## PLAN COMMISSION AGENDA

June 11, 2026 – 6:00 pm  
Village Hall  
235 Hickory Street, Pewaukee, WI 53072

TO: Village of Pewaukee Plan Commission  
CC: Matt Heiser – Village Administrator, Mackenzie Quigley - Clerk  
FROM: Mark Lyons, Planning Consultant  
RPT DATE: June 4, 2026  
MTG DATE: June 11, 2026  
RE: 5a – Two-lot CSM for Christian Brothers Automotive

TO: Village of Pewaukee Plan Commission  
CC: Matt Heiser – Village Administrator, Mackenzie Quigley - Clerk  
FROM: Mark Lyons, Village Planning Consultant  
RPT DATE: June 4, 2026  
MTG DATE: June 11, 2026  
RE: 5b – BPO Johnson Financial Group

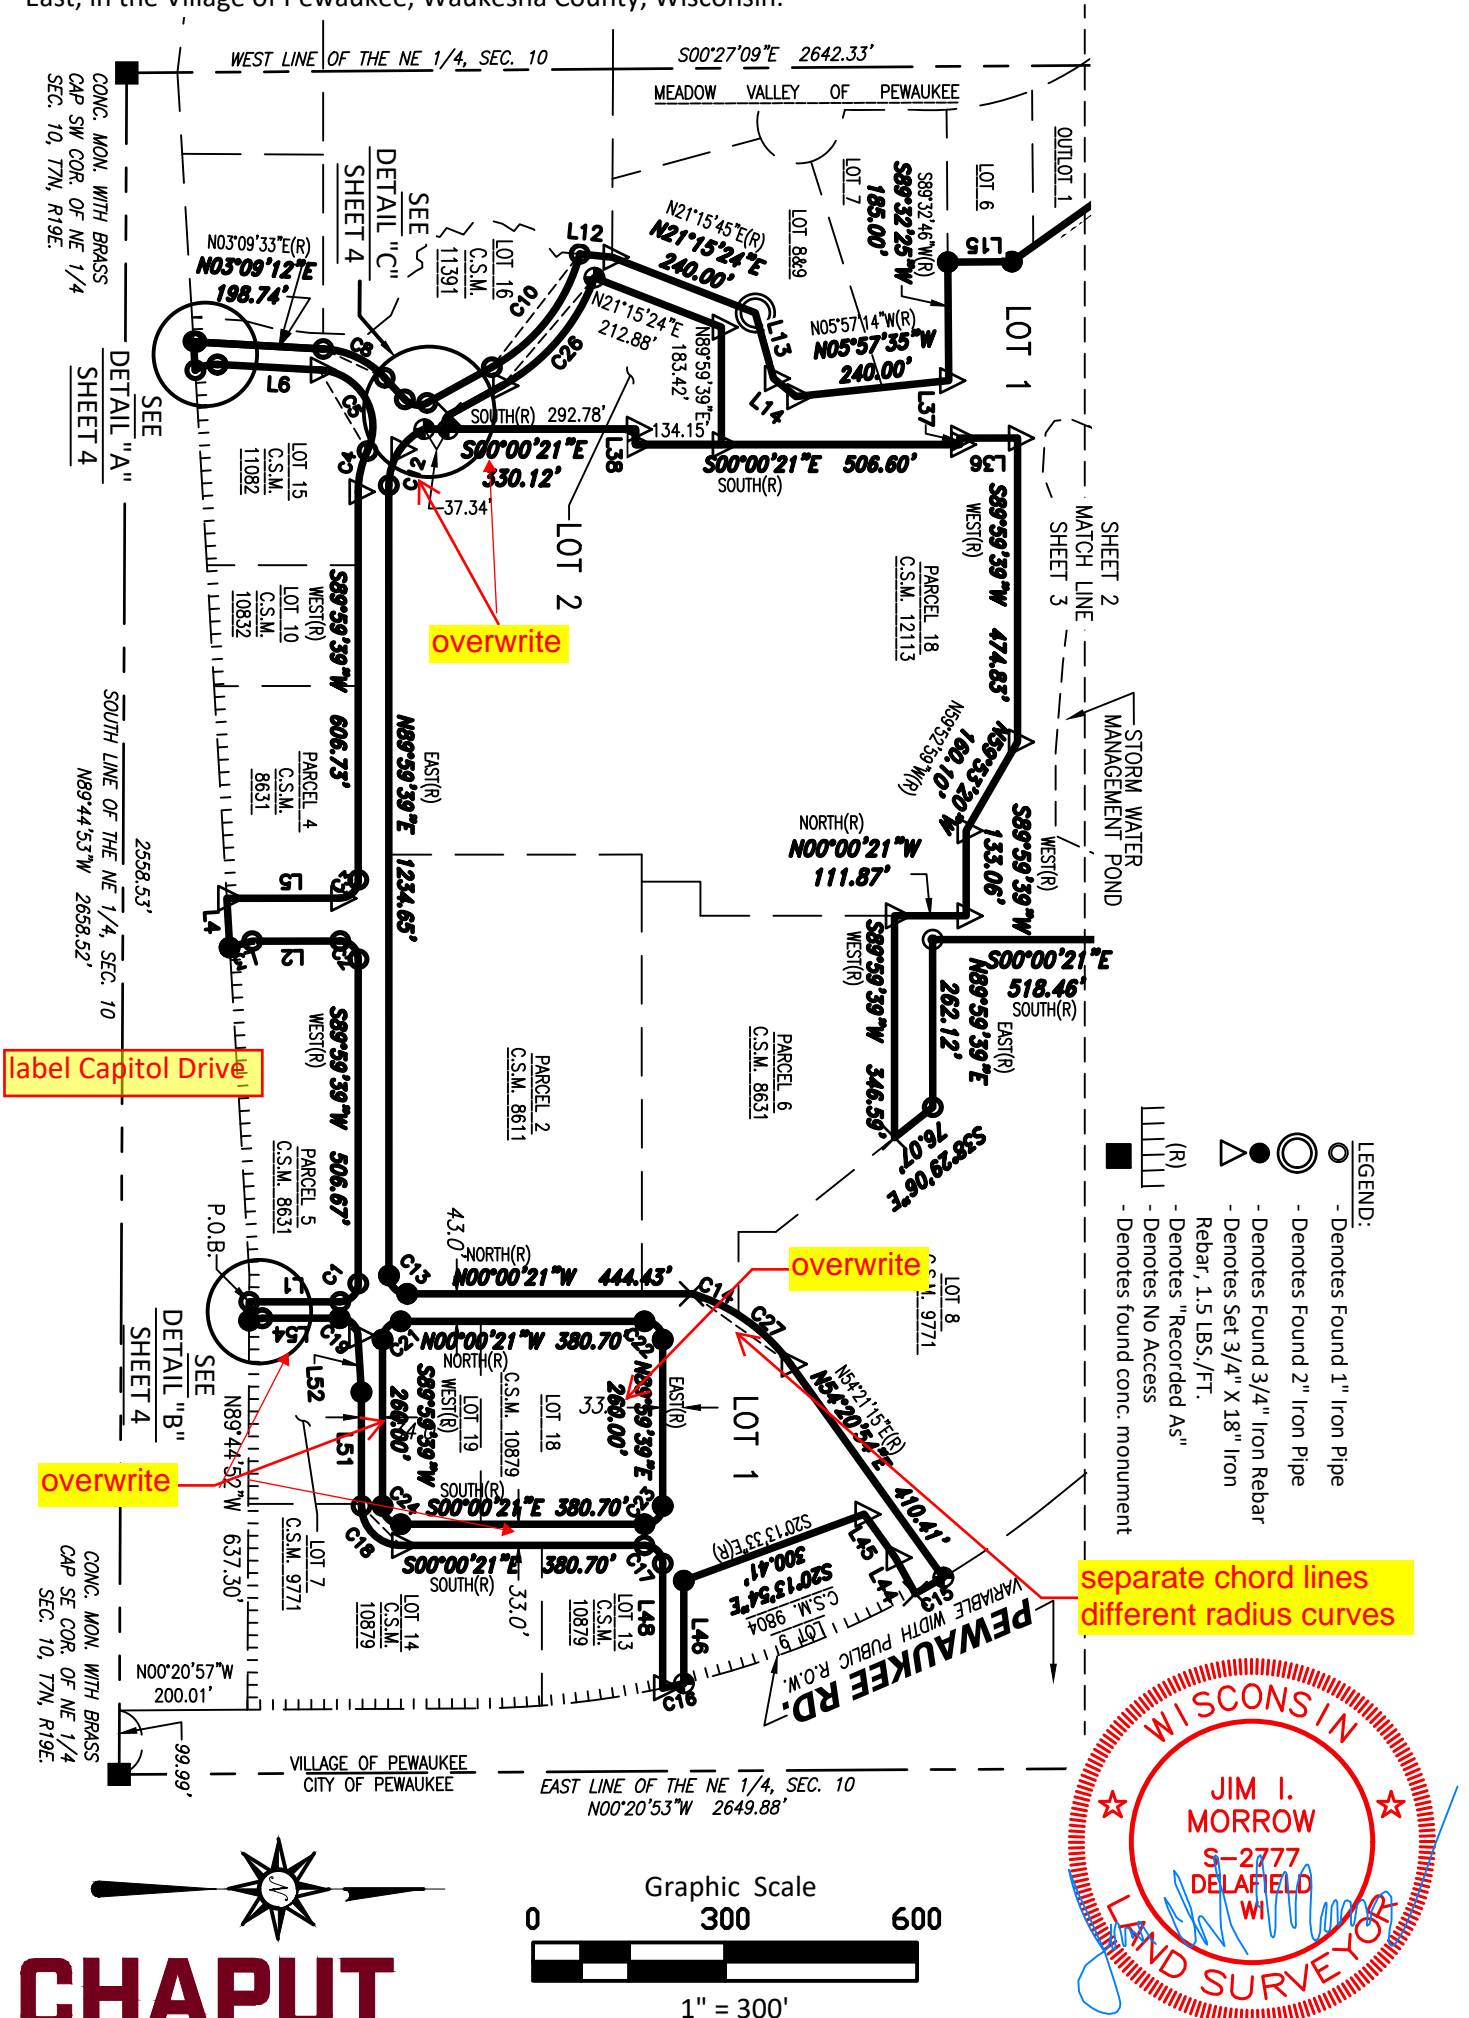
1. The CSM redivides a part of Lot 17, CSM 11391. Lot 17 was previously divided by CSMs 12113 & 126818. The heading and legal description should be revised to reflect this.
2. Show separate chord lines for curves C14 & C27.
3. The bearing reference needs to be corrected; we presume to the East Line of the NE  $\frac{1}{4}$  of Section 10.
4. Label W. Capitol Drive on sheets 3, 6, and 8. Also label Pewaukee Rd on Sheet 8.
5. We question if “dedicated” should be listed in the Owner’s certificate.
6. We recommend providing a detail at the NW corner of the NE  $\frac{1}{4}$  to detail if a monument was set at that corner and to depict dimensions to the meander corners.
7. We recommend a lighter pen weight on the boundary dimensions.
8. We recommend certain overwrites be revised, as shown.

separate chord lines  
different radius curves

### Sheet C100 – Site Plan

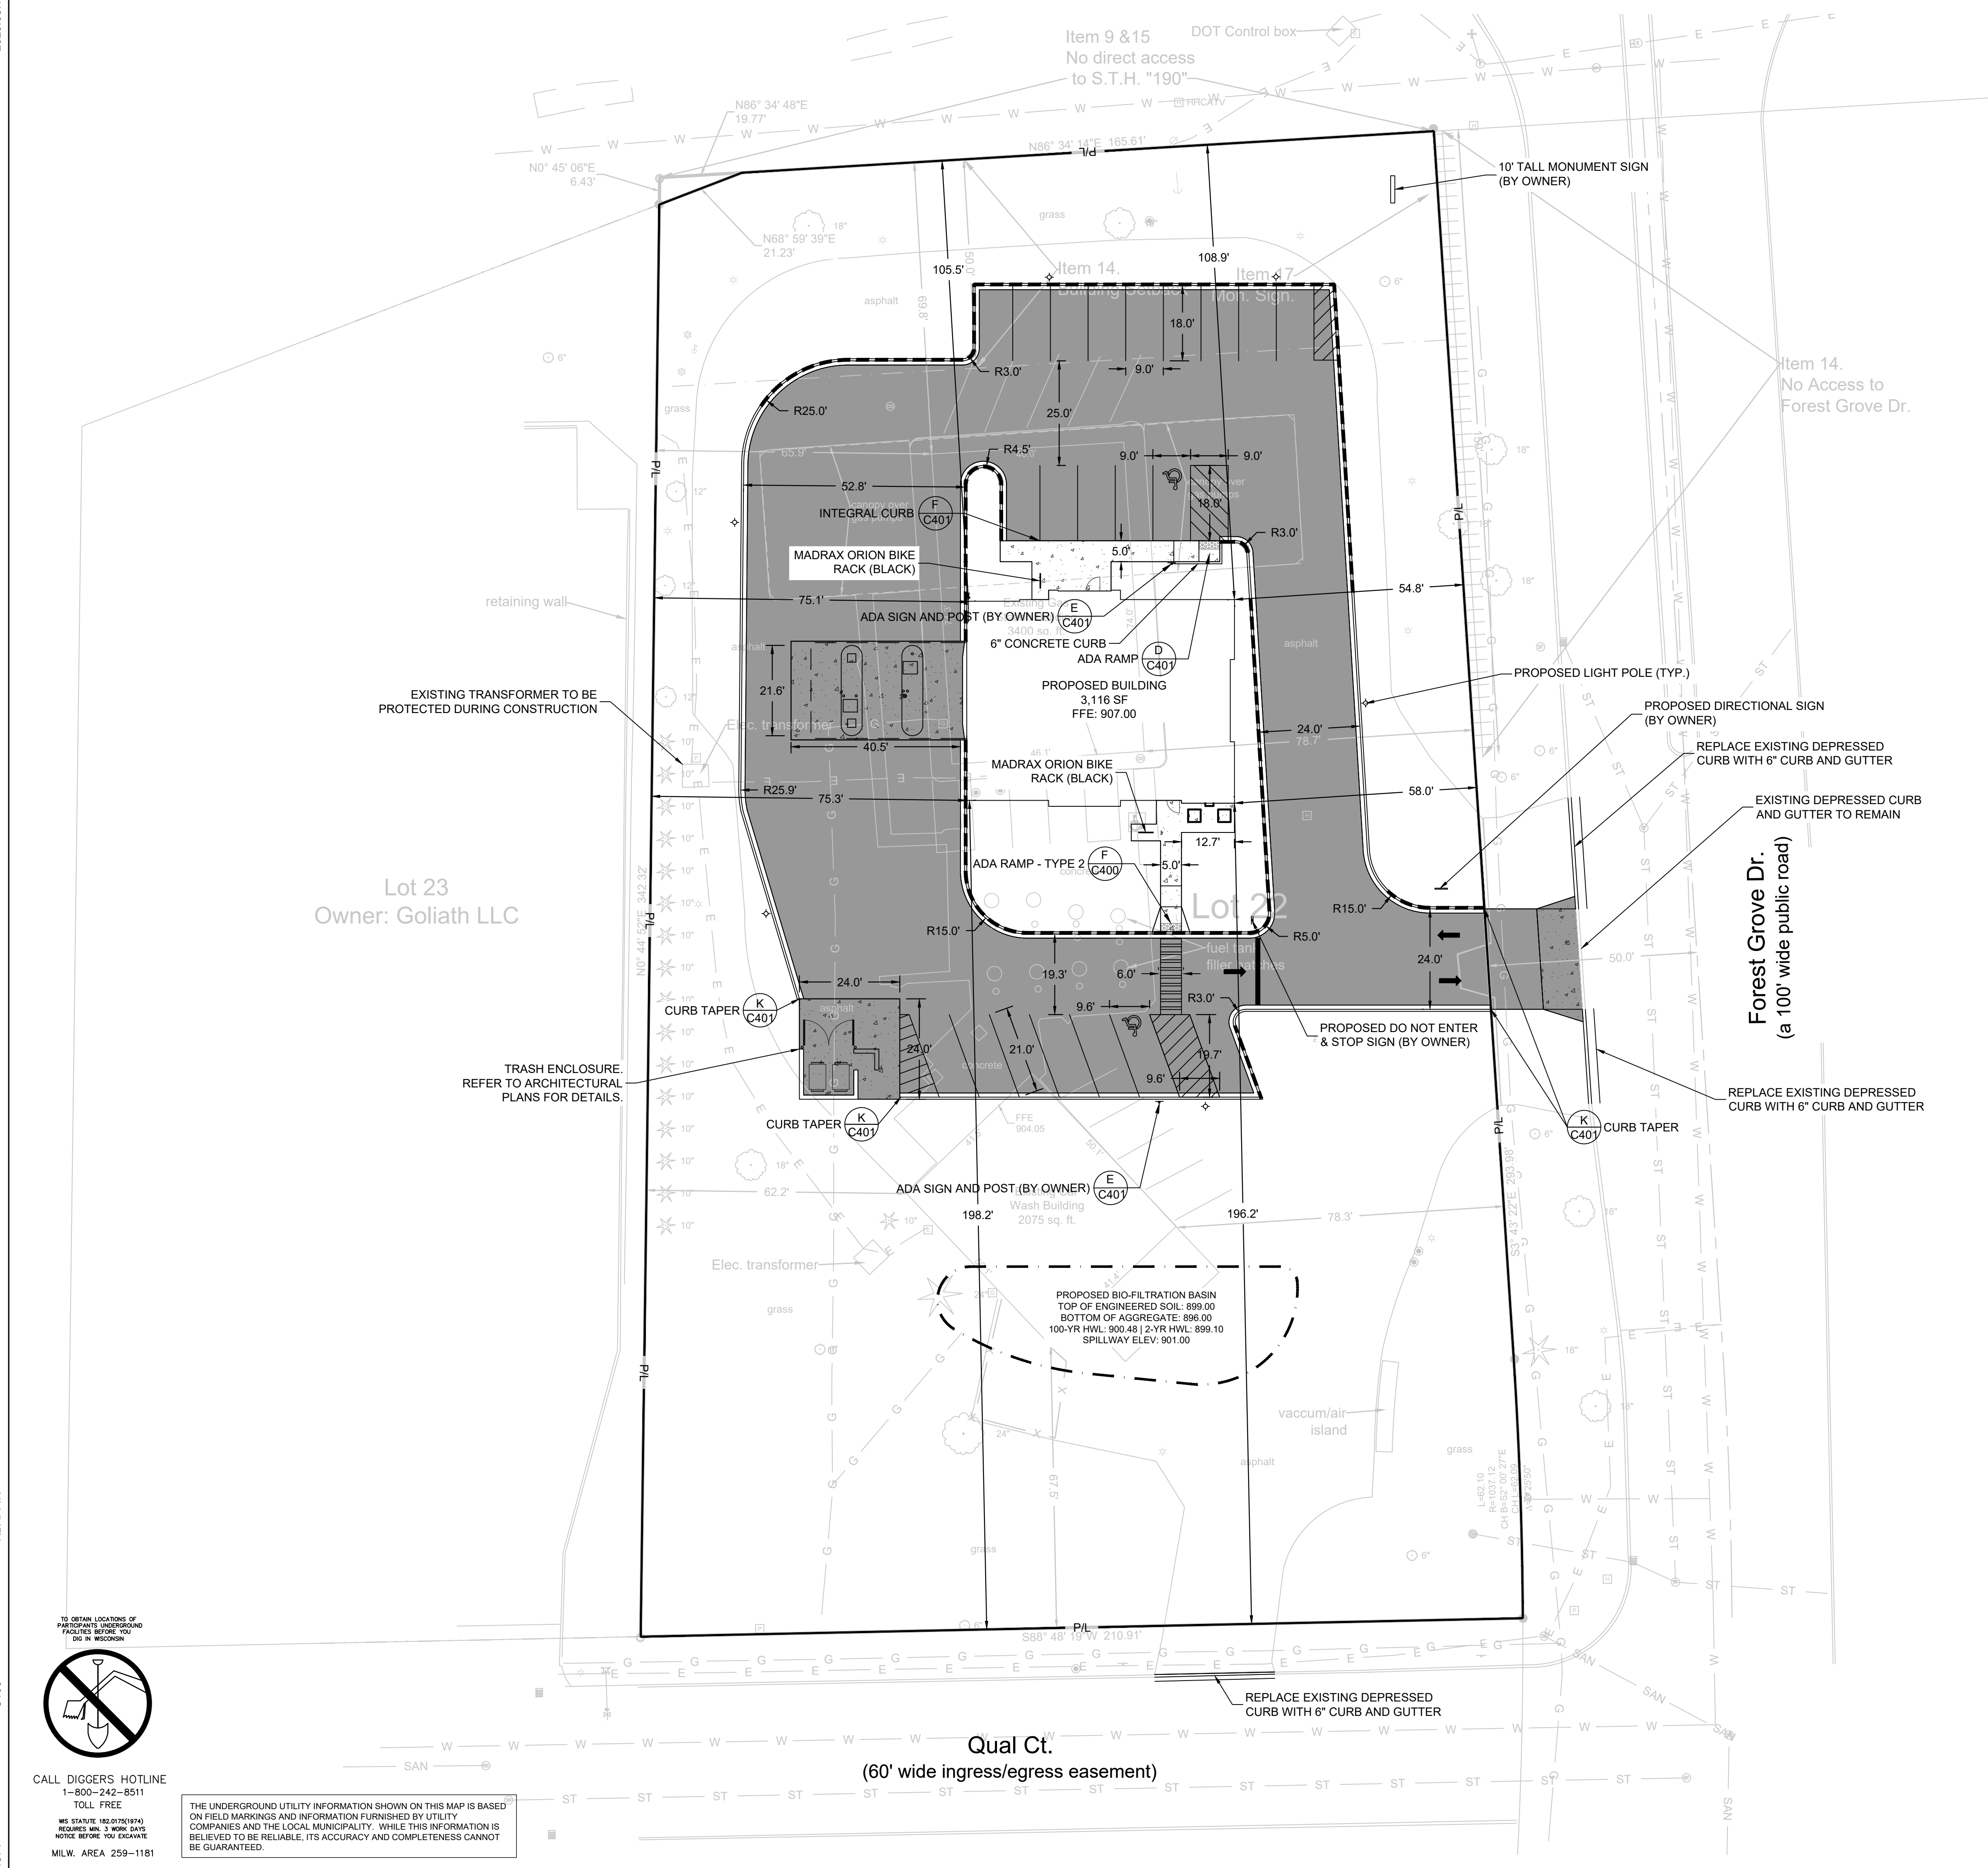
- b. There is a 65% maximum impervious area requirement, and this proposal comes in at 65.2%. The applicant will have to make minor modification to meet the ordinance requirements.

The applicant plan set does not include the required street planting along Capitol Drive. They will need to be added to meet the ordinance requirements.
